ADDENDUM NO. 3

POLYTECH HIGH SCHOOL
RENOVATIONS AND ADDITIONS
BID PACKAGE 'B'

This addendum is hereby made part of the Project Manual and Drawings dated 9 November 2012.

EPD1.1

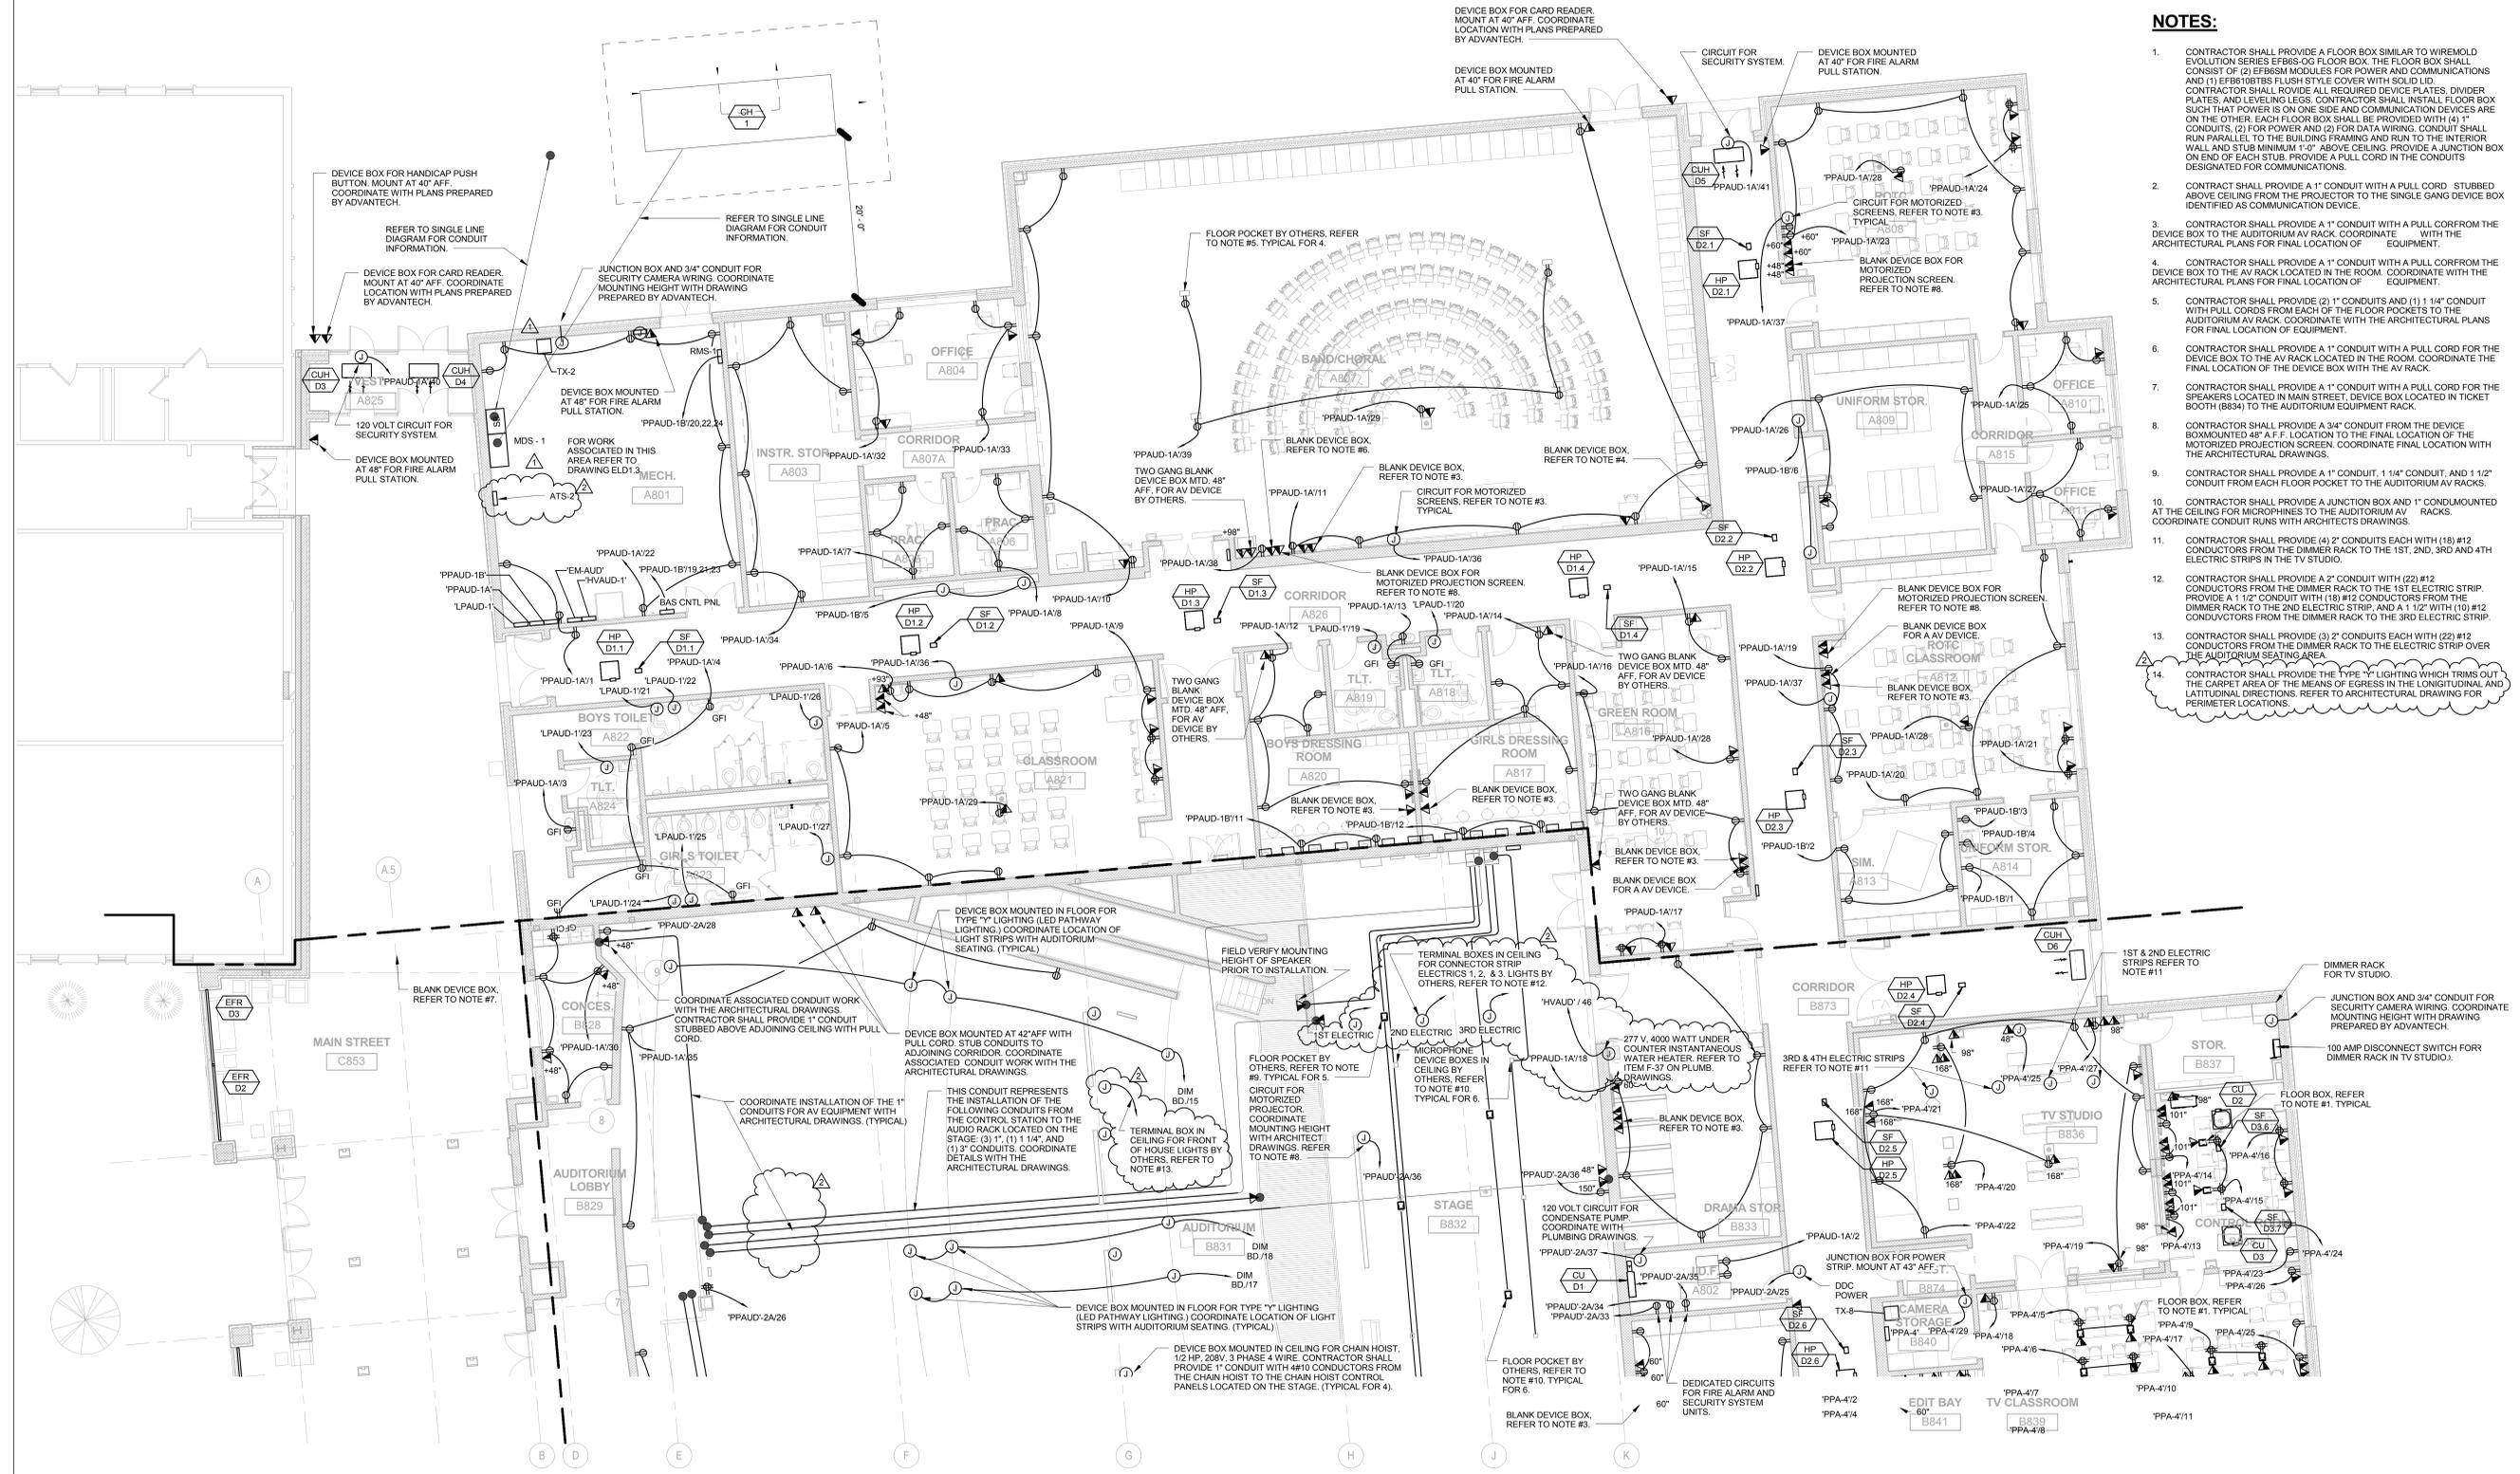
- Q. Drawing EPD1.1, "POWER PLAN AREA "B"
1. Revise drawing to show location of ATS-2. See revised Drawing EPD1.1.
- R. Drawing EPD1.2, "POWER PLAN AREA "B"

EPD1.3

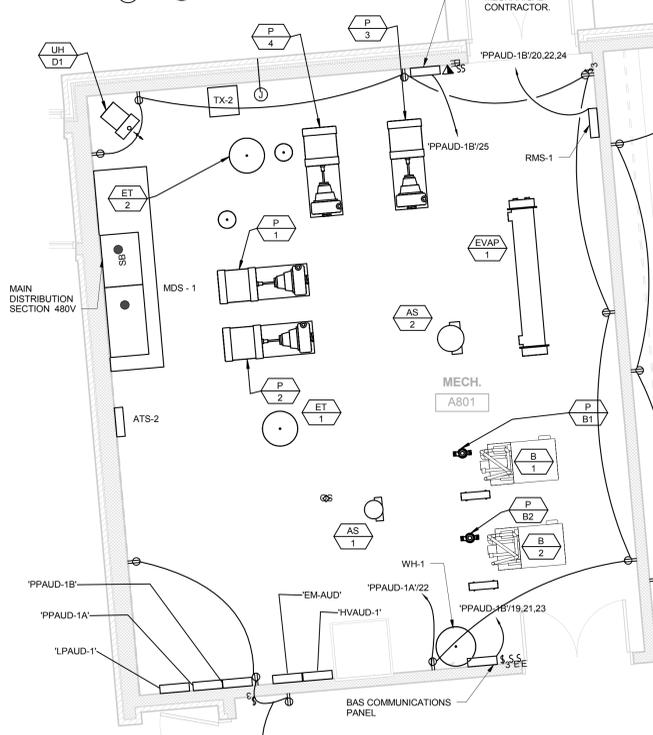
3. Clarify stage lighting power connections. See revised Drawing EPD1.2.
- S. Drawing EPD1.3, "POWER PLAN AREA "B"
1. Revise drawing to add power for water heater in room Janitor C869. See revised Drawing EPD1.3.
